Emergency release mechanism of the one piece canopy

Sailplanes DG-100, DG-100 G, DG-100 ELAN, DG-100 G ELAN

Technical Note No. 301/12

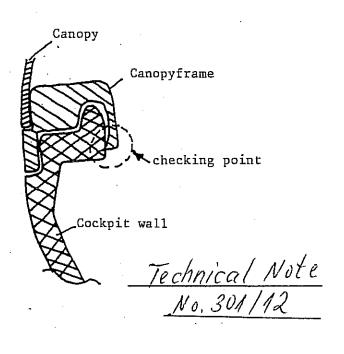
- A 1) Close canopy
- A 2) Keep canopy fastener closed. Pull emergency canopy release. The canopy has to lift itself in the front for 1-2 cm. If this doesen't happen, You have to do do the following:
- B 1) Inspect the welds of the stopping sheet at the fuselage side canopy fitting (look at the scetch). _

If they are projekting, You have to file them flat. (Protect the filed area with a rust protection paint afterwards.)

weld flat

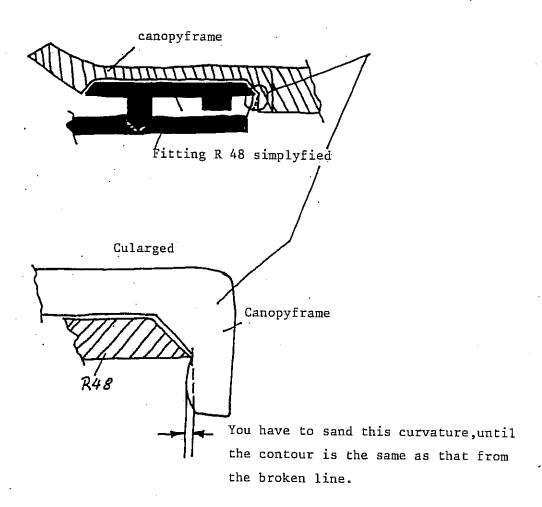
B 2) If this work was unsuccsessful, You have to check, wether the canopyframe undercuts at the inner bead in the front sector.

(look at the scetch)

If there are undercuts, (You can see it exactly at the rubpoints at the canopyframe and the cockpitwall) You have to eliminate them by sanding with an abrasive paper (60 Grit).
